A G E N D A

Architectural Review Board

March 23, 2021 – 5:30 p.m.

1923 Graham St.

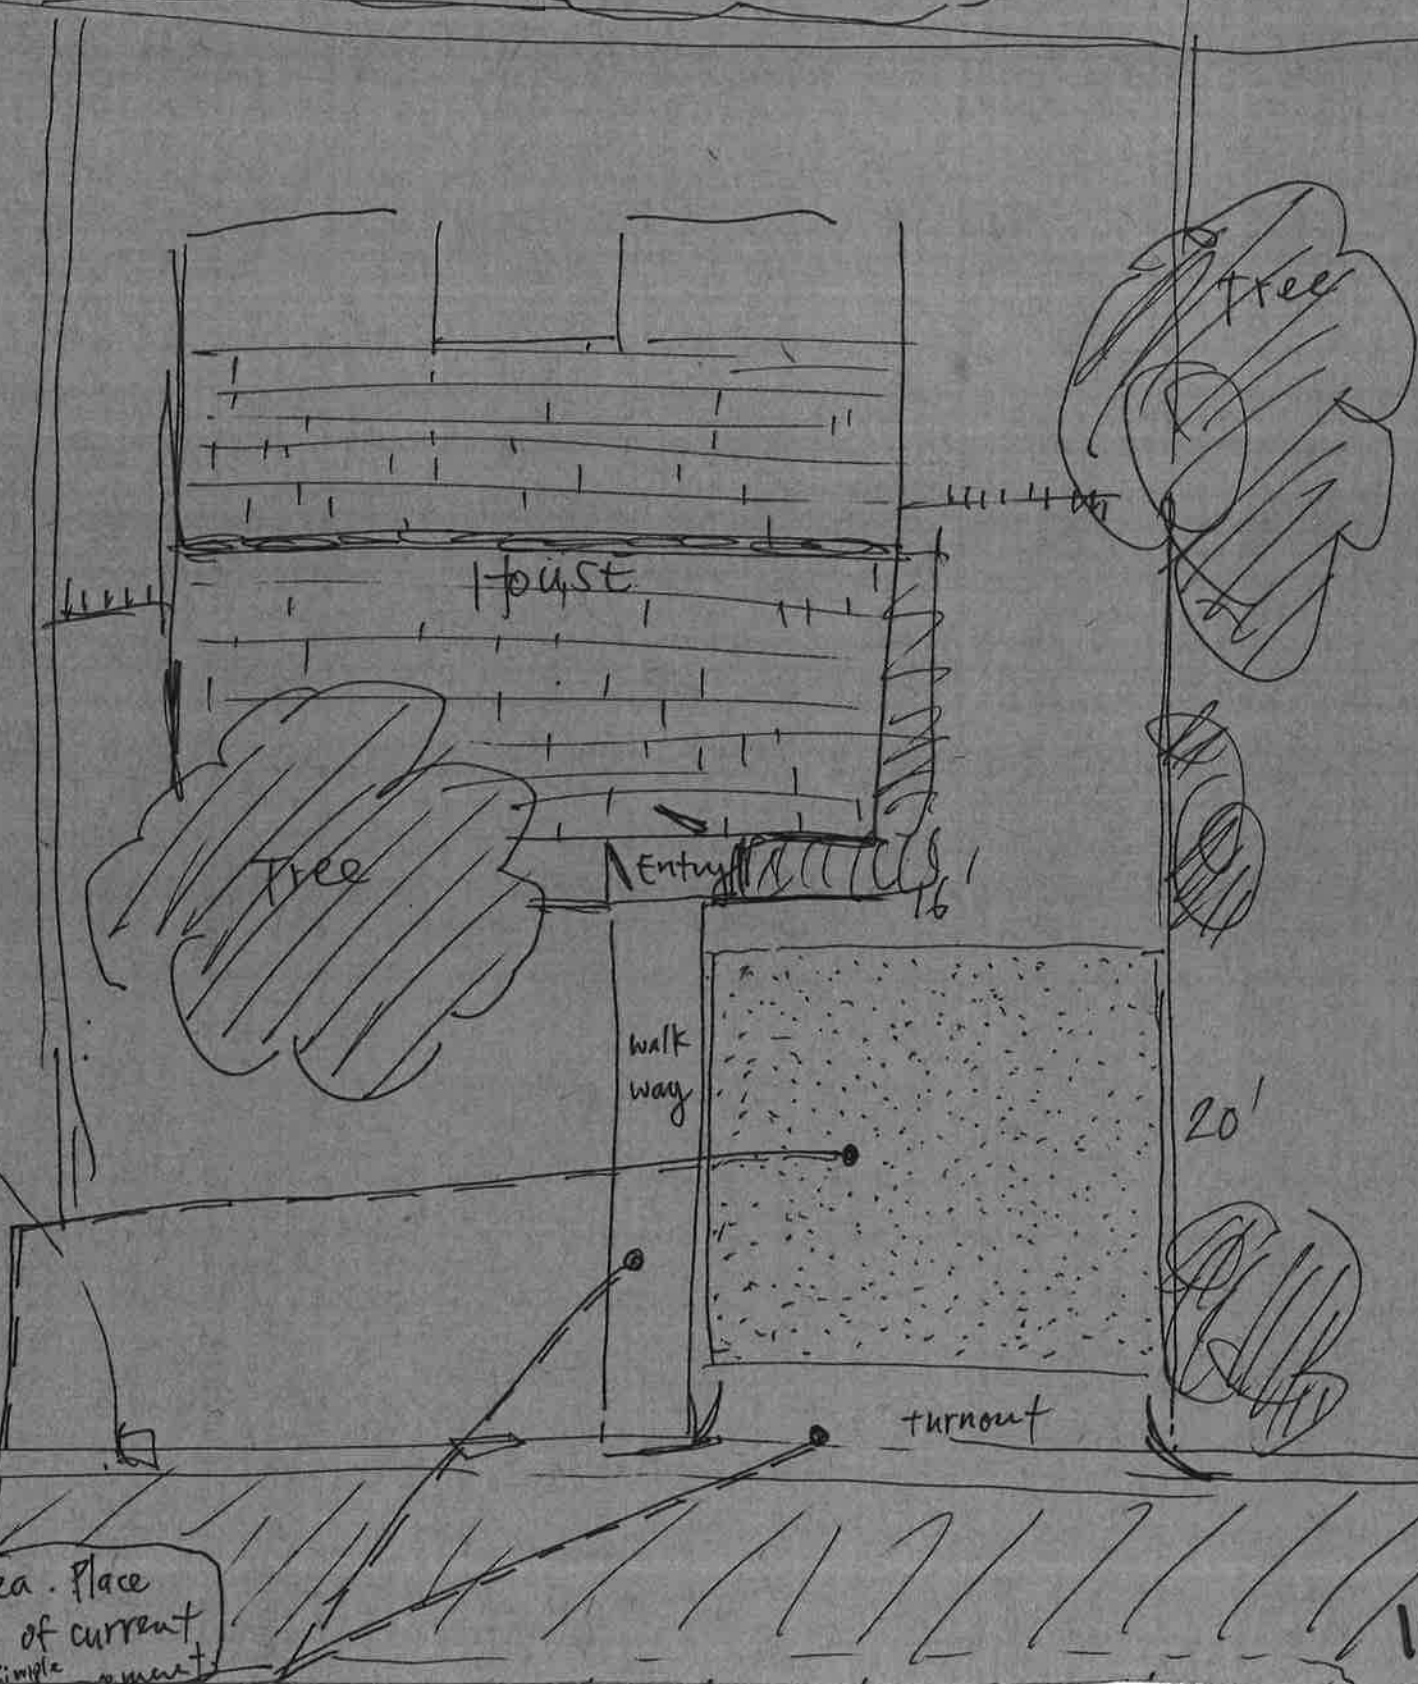
- Visually the biggest concern of staff is that the sidewalk was supplanted by the paving for the parking pad, removing any delineation of a walkway and connection between the house and the street. We have had requests for driveway expansions before the work was completed that came to a front walkway, the Board has generally required there be some separation and distinction between the two elements so the front walk is not available for parking and the pedestrian has a clear path.

After discussing the issue with Mr. Bagley, he indicated that he would like to leave it as is. But, if the ARB feels the walkway needs to be separated from the parking area, he would “demarcate the walkway with a small border of planters, masonry, or vegetation.”

1123 Westmoreland Avenue

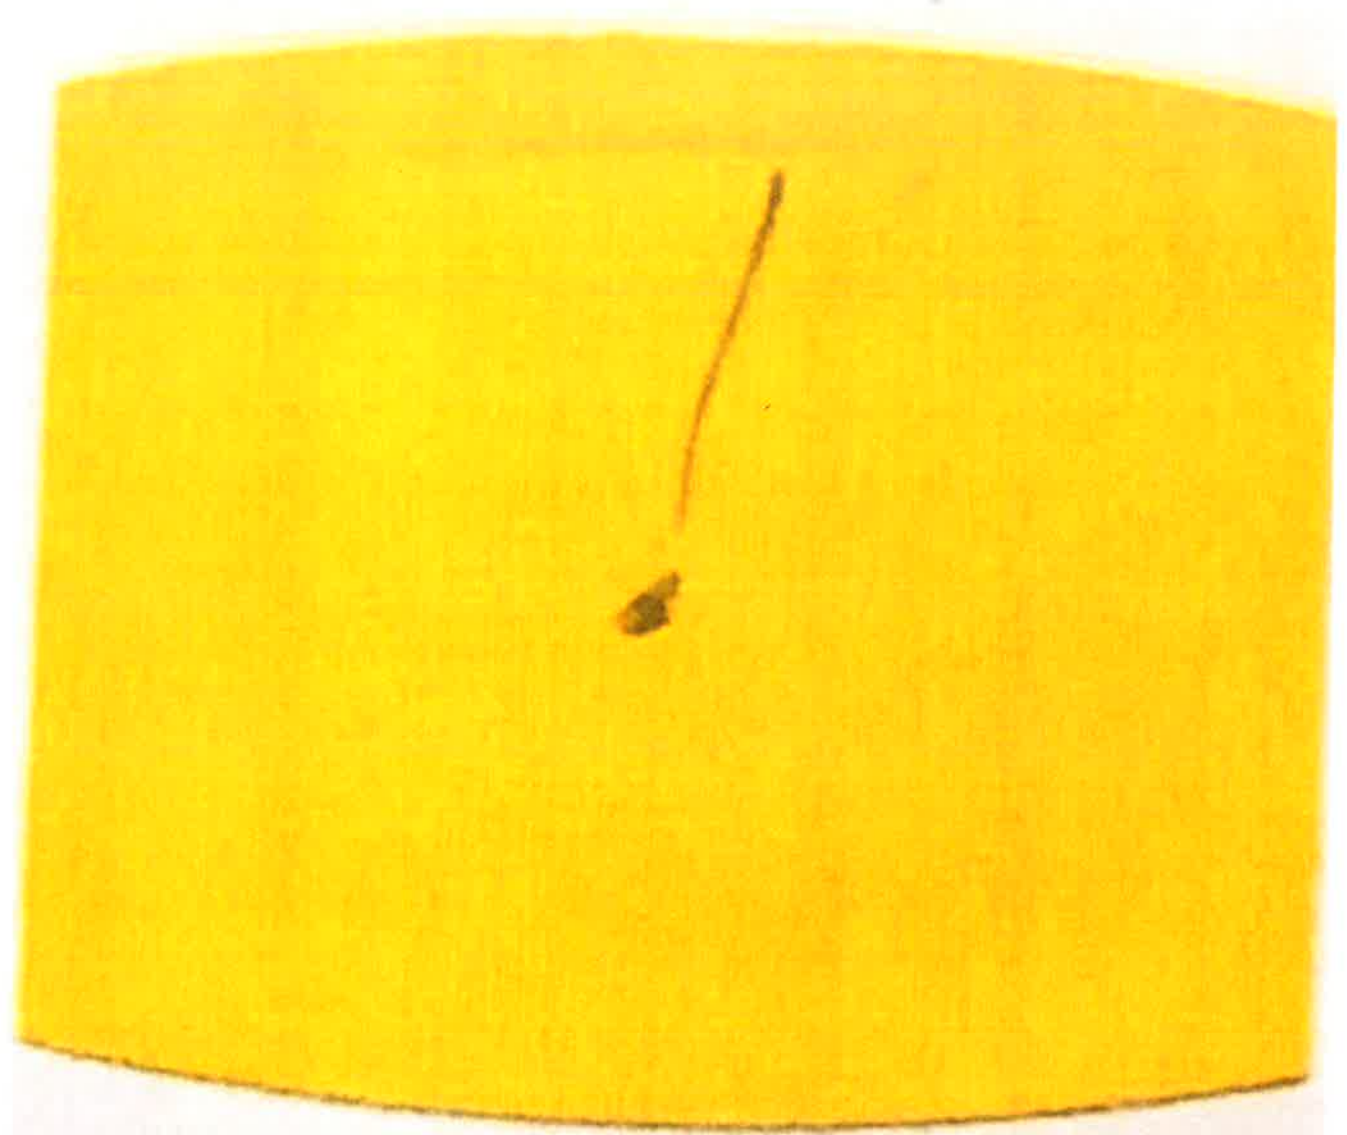
- This house was built in 1952 and does not have a lot of other detail. No objection to a pop of color on the door.

1910 Graham Street
Deck and Porch Elevation

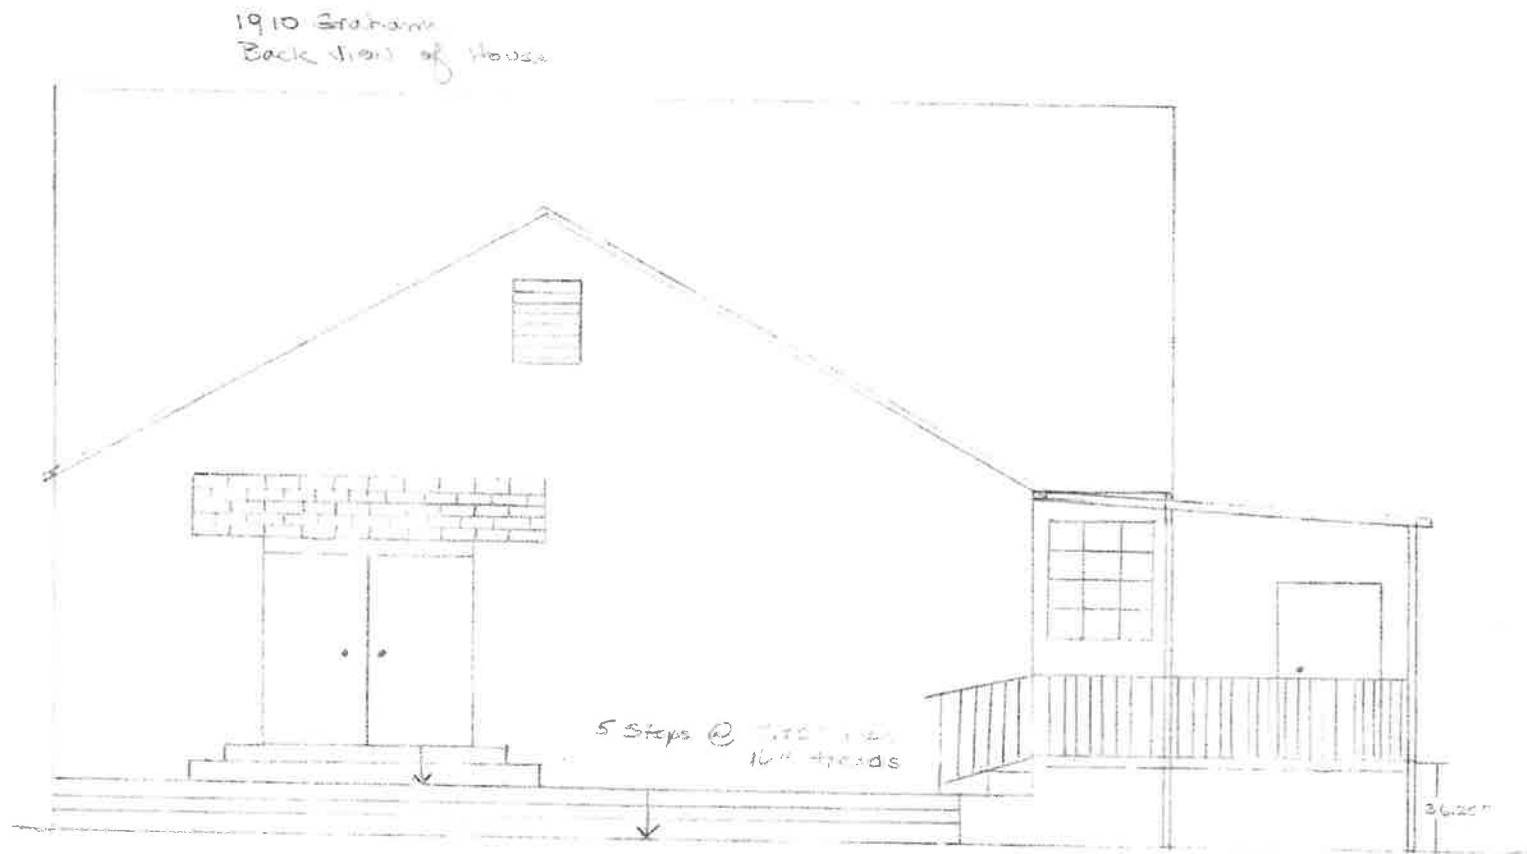
- Meets the required setbacks for the covered portion of the deck. No objection.

1817 Lockerbie
Fence Plans – Side Fencing

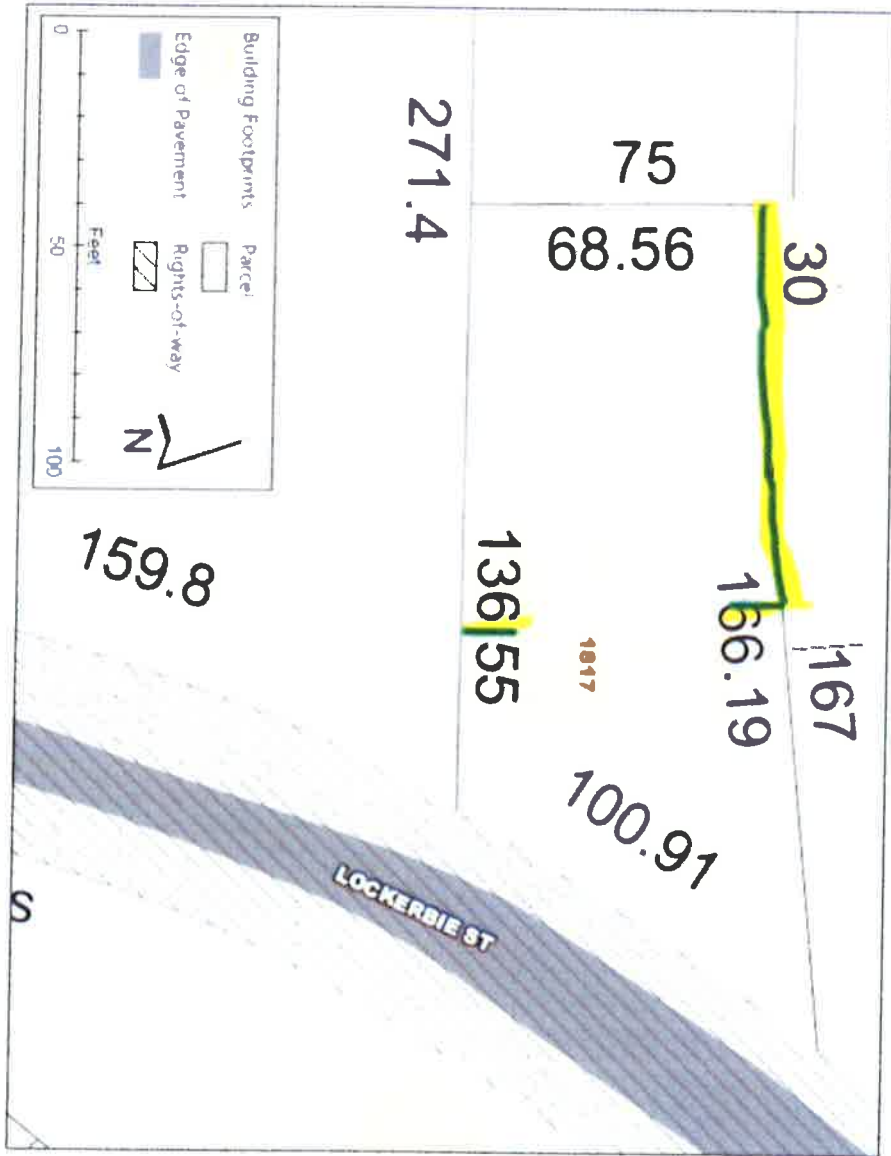
- 646 Cloverdale Road is also on the agenda with a fence petition for the same location. The Board’s only role is to determine if the fences are appropriate to allow each owner to demarcate their property. We often see petitions for new fences abutting fences on adjacent properties, which gives each property owner control over their enclosure.
- No objection.
